PUBLIC COMMENT on PROPOSED BUILDING STANDARDS

Rationale for Requesting Disapproval of Item 17 of Title 24, Part 2 Proposed by California State Fire Marshal

The basic reason that I, Marcelo M. Hirschler, request disapproval of item # 17 (sections 2603.2.1, 2603.3 and 2603.4.15) is that the proposed change will decrease fire safety. The following details are based on the flawed Oklahoma State University (OSU) report commissioned by the California State Fire Marshal.

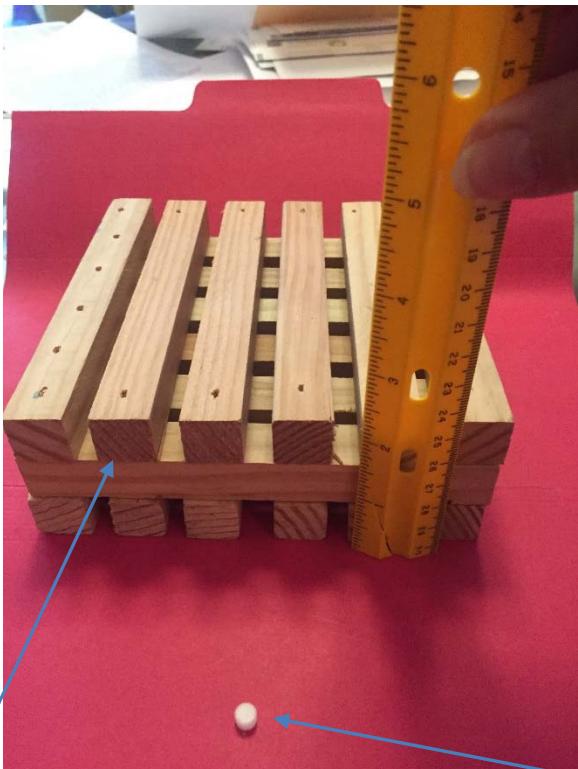
1. The OSU project demonstrated that fire retarded EPS (expanded polystyrene) foam was much less easily ignited than non-fire retarded expanded polystyrene (Non-FR EPS) foam.
2. The difference in ignition performance found by the OSU project was not minimal but very substantial. In detail, the ignition source in ASTM D2859 (which ignited the Non-FR EPS foam) is a methenamine pill that weighs 150 mg and has the approximate size of a shirt button (meaning that about 200 pills weigh an ounce) while the Class B ignition source from ASTM E108 (which was needed to ignite the FR EPS) is solid wood that weights 500 g (over a pound). There is no realistic comparison between the ease of ignition of the FR EPS foam and the Non-FR EPS foam. See photographs below.

Figure 9 FR EPS vs Non-FR EPS Methenamine Pill Test ASTM D2859

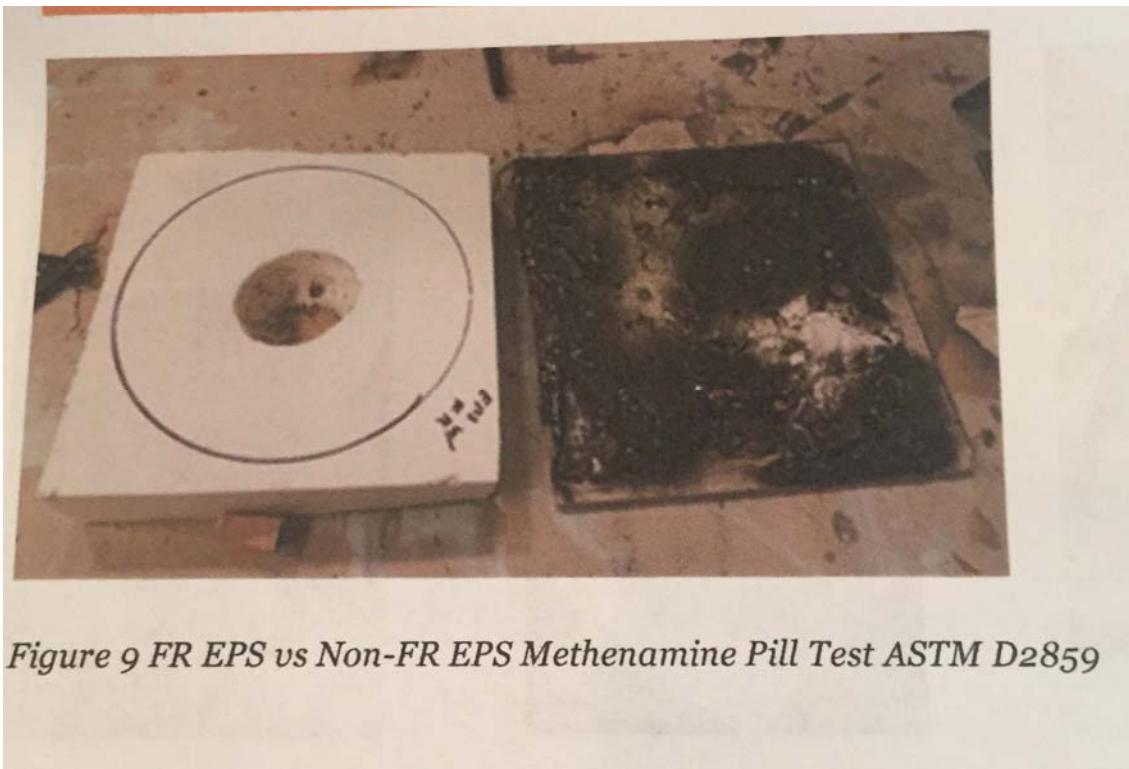
4. The photograph below shows, taken by OSU, the results of applying the methenamine pill to FR EPS foam (on the left) and Non-FR EPS foam (on the right): the difference is astounding.
